**Our Ref** DS/FS25/0025

**Your Ref** PT\_A ZT/25/00529/FULEIA

**Subject** 130 Fenchurch Street London EC3M 5DJ

<b>Application reference:</b> 25/00529/FULEIA		<b>Address:</b> 130 Fenchurch Street		<b>Date:</b> 16/07/2025	
<b>Proposal:</b> Phased development for the demolition of all buildings and structures to existing slab level, erection of a new building comprising 3 basement levels, ground plus 34 storeys (161.46m AOD, 145.86m AGL) to provide a mixed use office (Class E(g)), culture (Class F1/E), public viewing gallery (Sui Generis), flexible retail (Class E(a)-(b)) development with soft and hard landscaping, pedestrian and vehicular access, cycle parking, flexible public realm including programmable space with associated highway works and all other works associated with the development.					
<b>More info needed</b>	<b>No Objection</b>	<b>No objection</b>	<b>Concerns Raised</b>	<b>Objection</b>	
	X				
<b>Initial Observations</b>		<b>Transport Officer:</b>		<b>DM Officer:</b>	
<b>Full Observations</b>	x	Taluana Patricio		Alex Thwaites

Figure 4-1: Footway Assessment Locations and Existing Widths

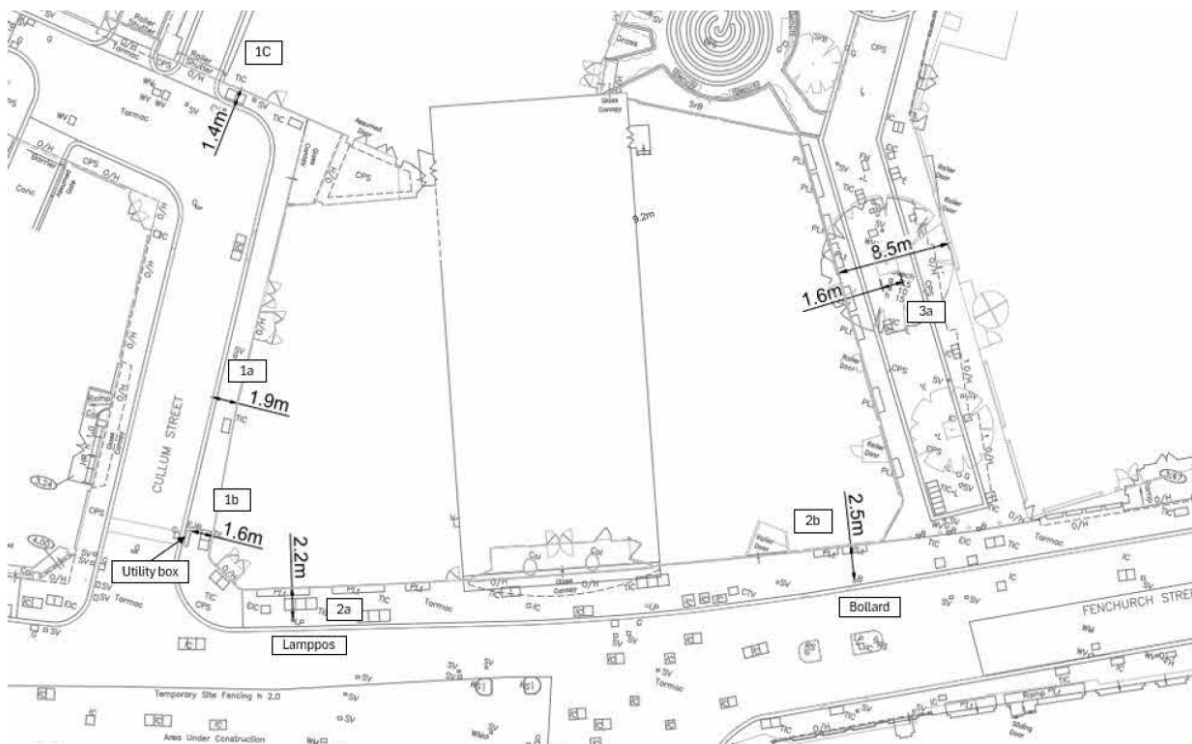
Footway widths were surveyed at four strategic points around the site, capturing both standard dimensions and any pinch points where relevant. These measurements reflect the current building lines and the full extent of the footway, as shown in the table below and on table 4.6 from the transport assessment.

Figure 4-6: 2024 Base Pedestrian Flows Diagram

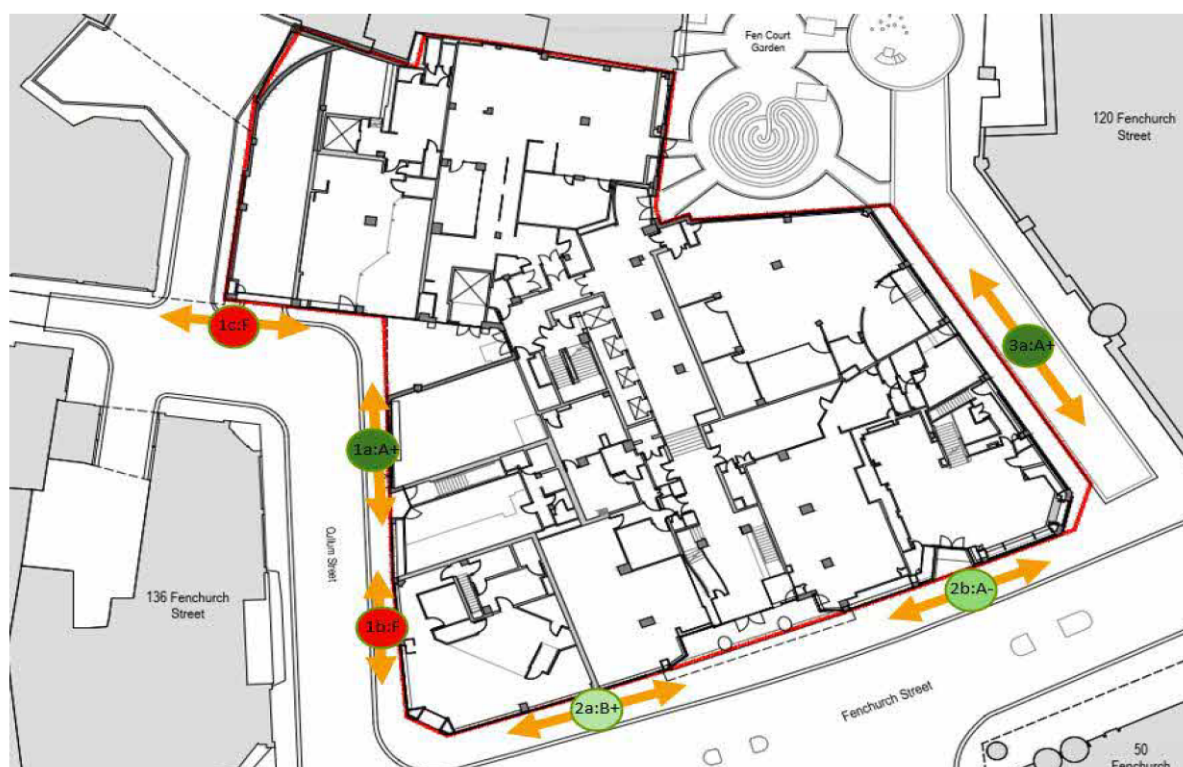
In the existing scenario (as shown above), all footways, except for the pinch point on the eastern side of Cullum Street (sections 1b and 1c), achieve a Pedestrian Comfort Level (PCL) of C+ or higher. However, Cullum Street (1b, 1c) consistently records a PCL of F across all time periods due to congestion caused by the pinch point. Fen Church Street (sections 2a and 2b) maintains a PCL of B+ to A-, indicating moderate pedestrian volumes. Meanwhile, Fen Court (4a) achieves a PCL of A+ throughout the day, reflecting a high level of pedestrian comfort.

Figure 4-9: 2040 Base Pedestrian Flows Diagram

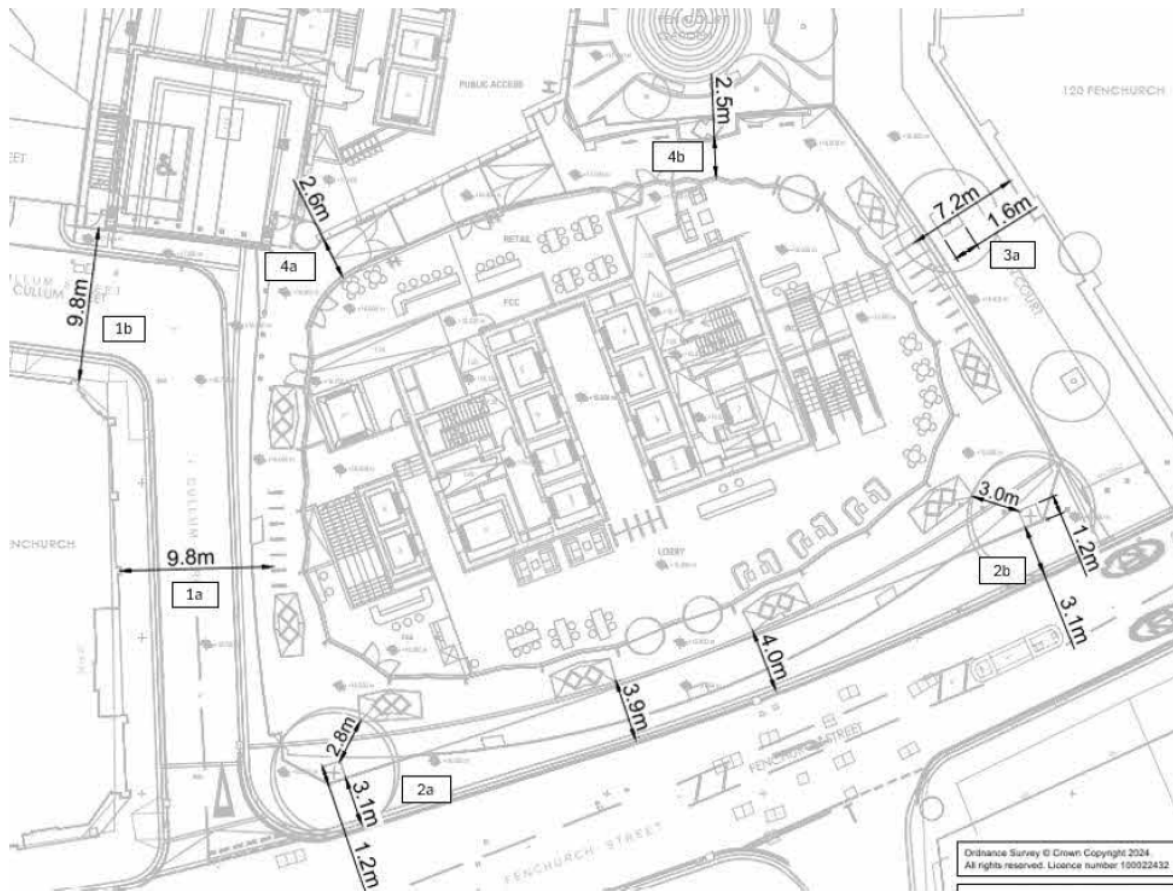
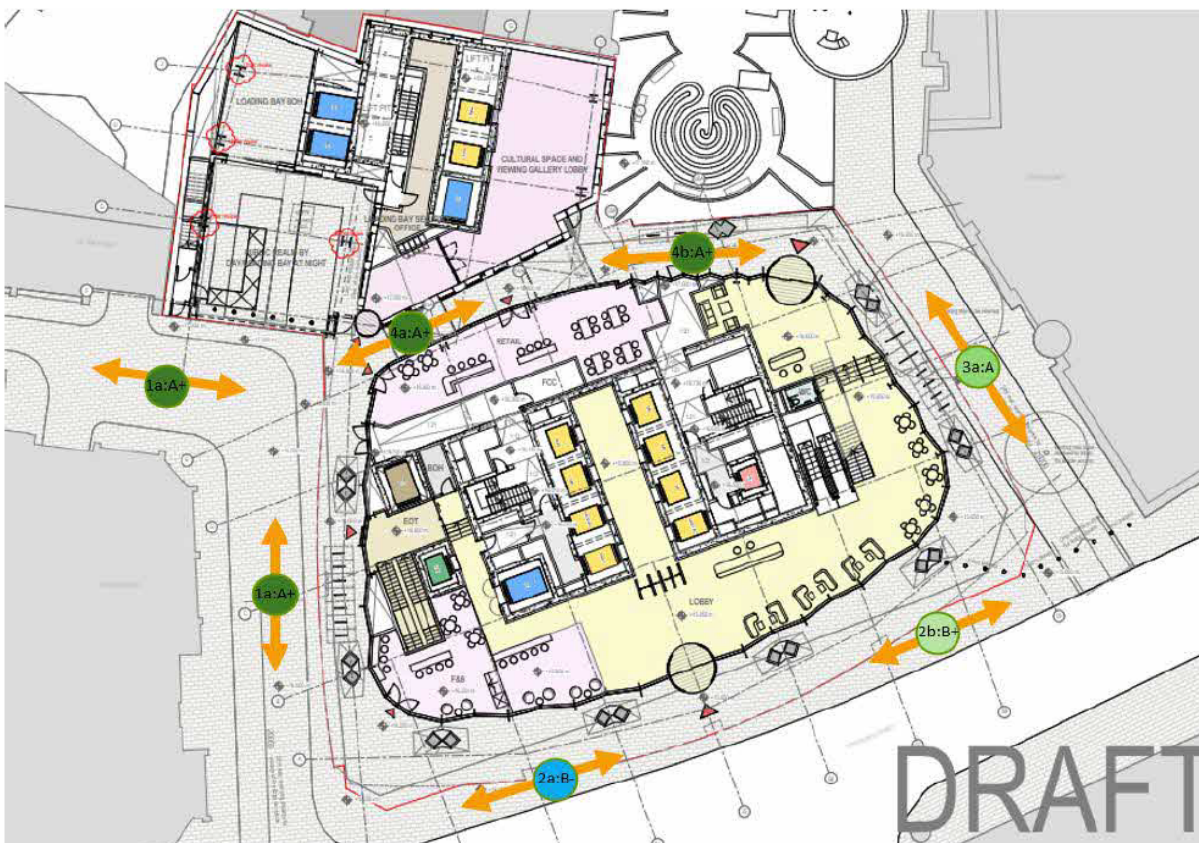
In the proposed (2040 baseline) scenario, all footways—except the eastern side of Cullum Street (1b, 1c)—achieve a Pedestrian Comfort Level (PCL) of C+ or higher. Cullum Street continues to experience a PCL of F due to congestion at a pinch point. Fen Church Street (2a, 2b) sees increased pedestrian flows but maintains a PCL of B+, while Fen Court (3a) consistently achieves A+. Overall, pedestrian flows rise across all locations compared to 2024, but comfort levels remain stable, with Cullum Street being the only area with poor performance. See below extract diagrams of the transport assessments.

The Proposed Development will transform Cullum Street into a raised shared space designed to accommodate all road users, enhancing both accessibility and the pedestrian experience. It will also create a pedestrian-only link between Cullum Street and Fen Court, along with improvements to Fenchurch Street. The footways fronting the site will benefit from increased width, incorporating both public highway and private areas. Figure 4-8 illustrates the proposed future footway widths.

These improvements will be delivered as part of a Section 278/38 Agreements and are designed to mitigate pedestrian impacts while significantly enhancing walking conditions in the surrounding area. They also support broader transport sustainability objectives by improving the quality of the pedestrian environment around the site.

Figure 5-1: Proposed Servicing Arrangement

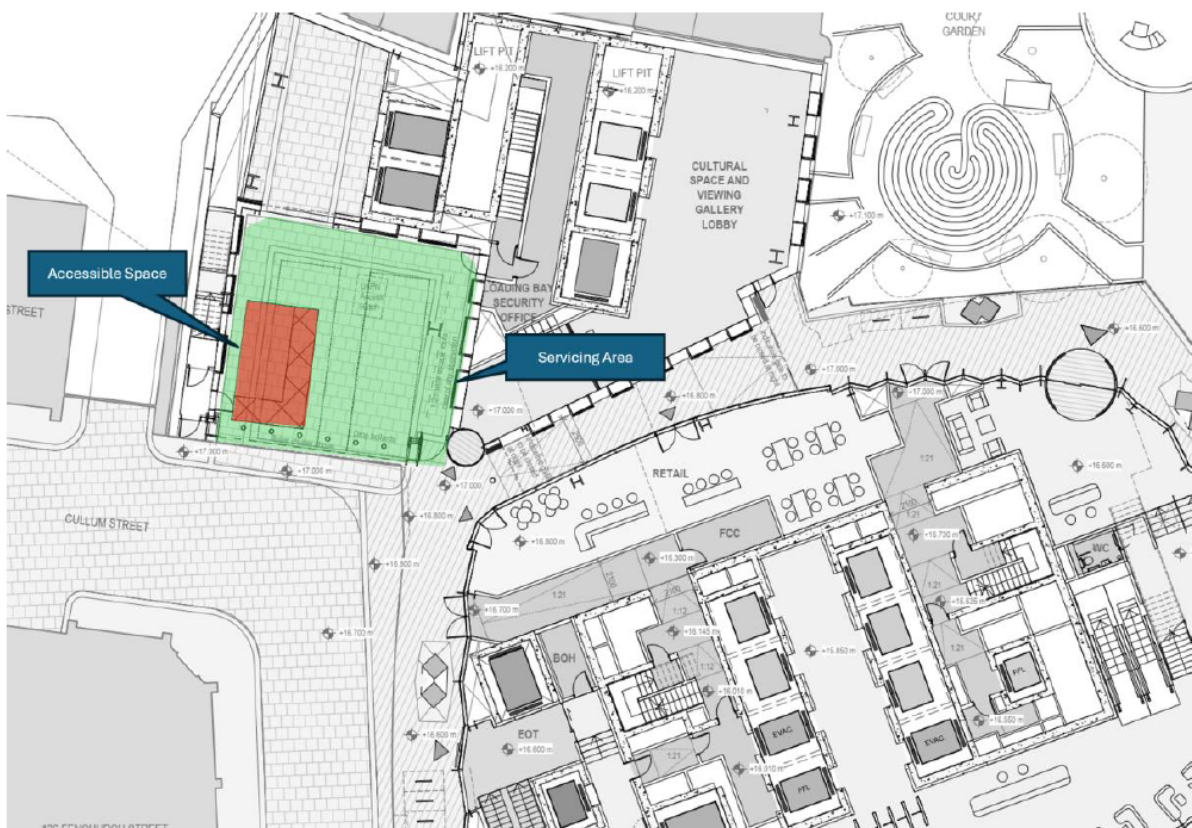
During the day, cargo bikes can use the servicing yard as seen in the below image and extracted from the transport assessment. Vehicle access will be limited to an 8m rigid lorry, which must reverse into the site, while smaller vehicles like Transit Vans can manoeuvre in forward gear.

The Proposed Development will include two dedicated loading bays within the service yard, designed to meet servicing needs while allowing safe vehicle manoeuvring and forward egress onto Cullum Street, as confirmed by swept path analysis. A Road Safety Audit of both the Cullum Street improvements and servicing strategy raised no safety concerns.

If planning permission is granted, a Delivery and Servicing Management Plan (DSMP) will be secured through the Section 106 Agreement and monitored for five years. To avoid conflicts with delivery and servicing activities and to comply with the permitted hours of use, it is recommended that refuse and recycling collections be integrated into the same system that manages delivery and servicing slots.

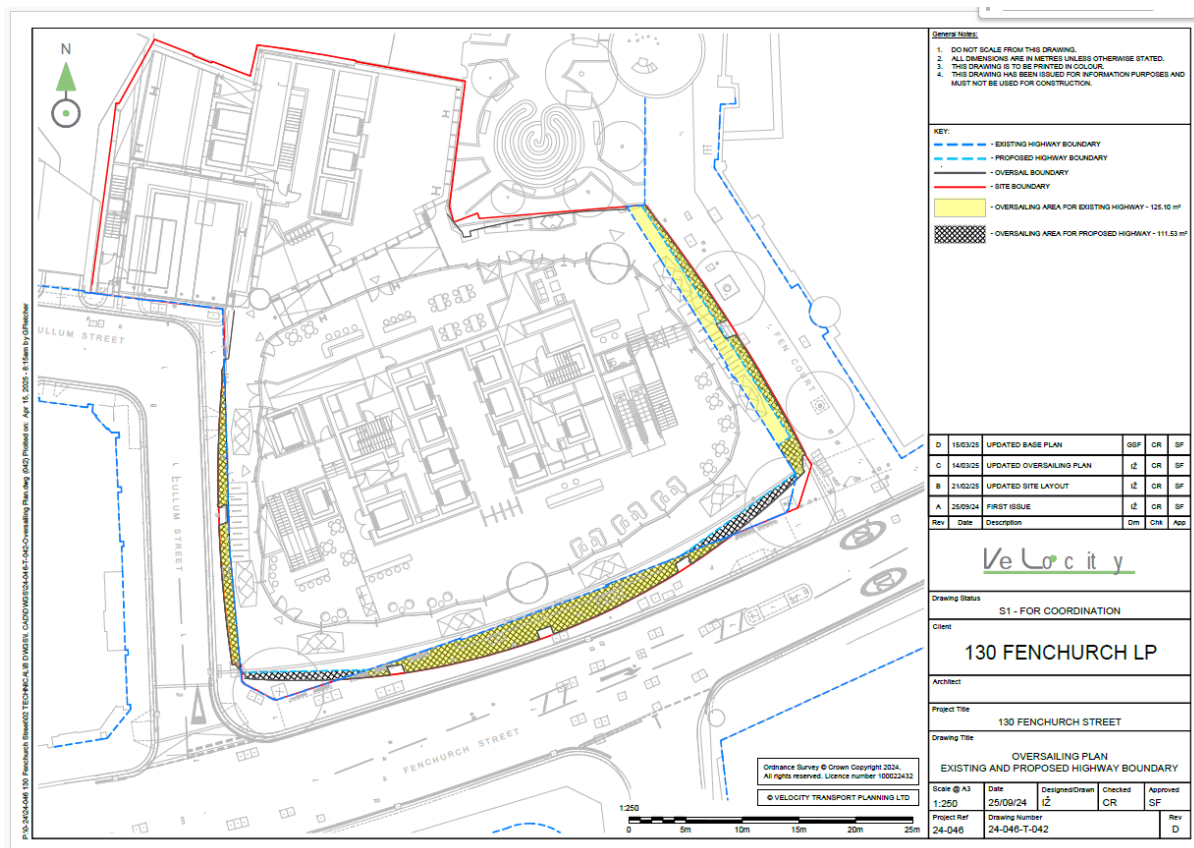
This development proposes both oversailing and undersailing, which are subject to the licences mentioned above, as referenced in Drawing No. 24-046-T-042.

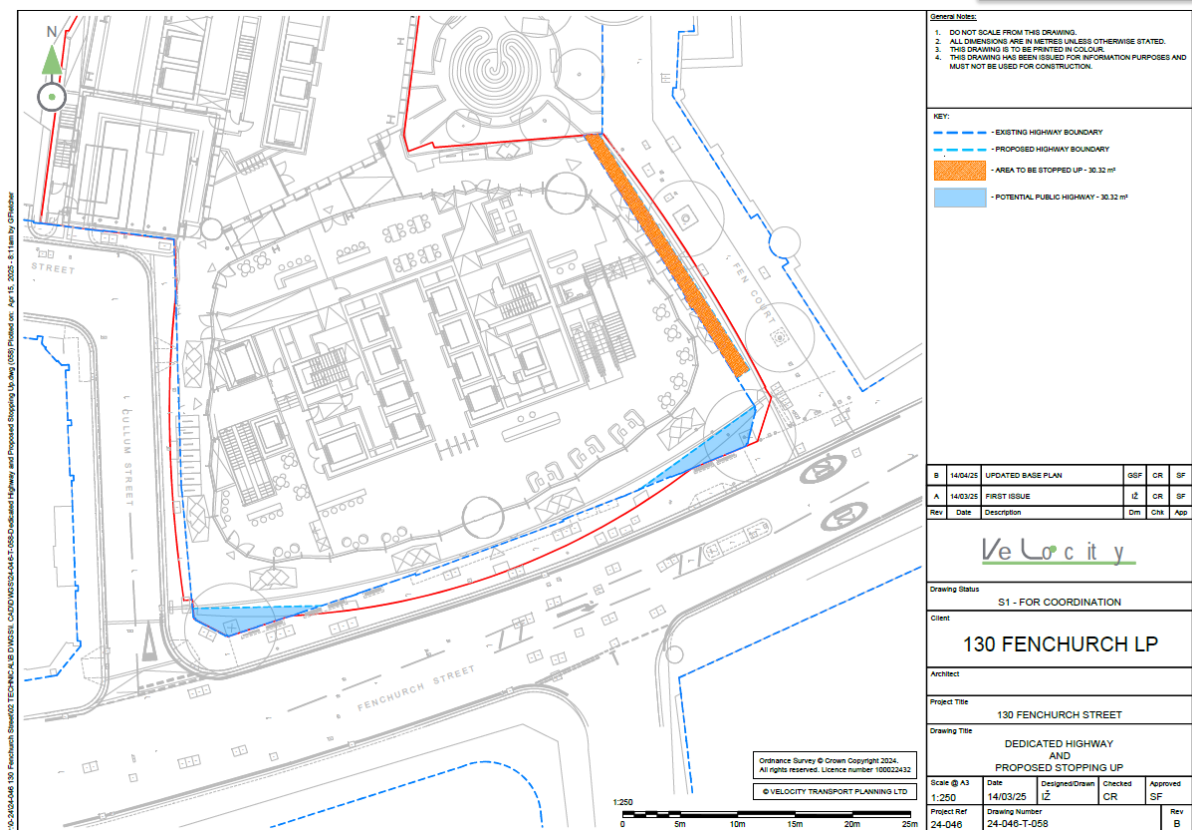
The submitted application includes proposals (Dwg No. 24-046-T-058) to stop up a section of the public highway located within the site boundary. The area in question encompasses the footprint of structural columns that would be positioned within the public highway and has been extended to establish a more coherent and rationalised highway boundary along Fen Court.

To compensate for the loss of public highway, two areas along Fenchurch Street are proposed for adoption, ensuring that the total area dedicated to public highway remains equivalent to the land being stopped up. In addition, the proposals will deliver a significant increase in

4. Prior to the commencement of any construction works, the applicant is required to apply for a stopping up order under Section 247 of the Town and Country Planning Act 1990, which allows for the closure or diversion of highways to facilitate development. The application should be submitted to the planning authority, including evidence of the granted planning permission and detailed plans showing the current and proposed site layout, as agreed during the planning stage. For detailed guidance on the application process and requirements, applicants should refer to the Department for Transport's official guidance on stopping up and diversion of highways at:

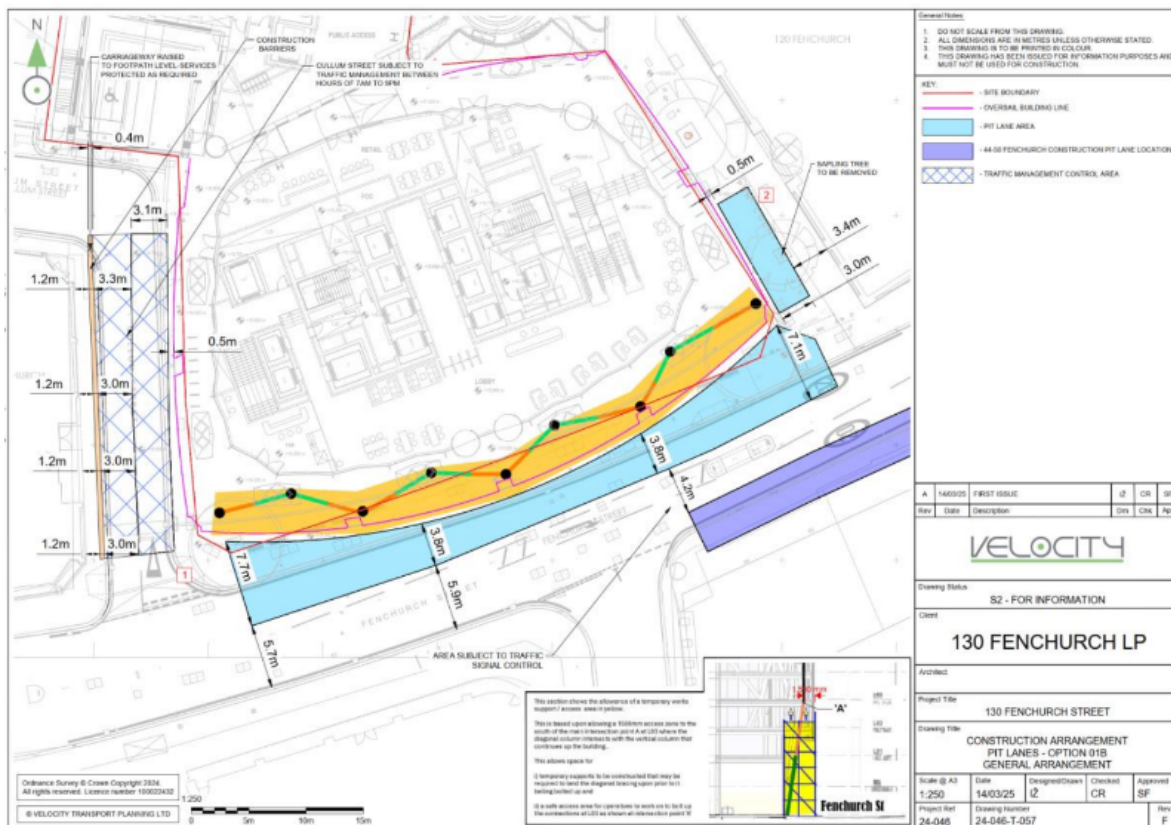
The proposal (see figure below) is also likely to lead to various amenity issues for local businesses that need to be carefully managed (e.g., noise, vibration, air quality).

This plan provides information describing the proposed works and how, at this preliminary stage, they could be undertaken. It also details how the impacts associated with the construction period would be mitigated and highlights concerns of local stakeholders early on to ensure these are accounted for within the detailed Construction Logistics Plan. This requirement should be secured by condition and prepared once a Principal Contractor has been appointed.

If planning permission is granted, the submission of a detailed CLP should be secured separately via condition to ensure the construction and demolition of the site comply with The London Plan Policy T7 and DM16.1 of the City of London Local Plan 2015 and with the emerging City Plan 2040. This would provide a mechanism to manage and mitigate the impacts the proposed development would have on the local area. The detailed CLP would need to be approved by the City of London prior to the commencement of works on site, should planning permission be granted.
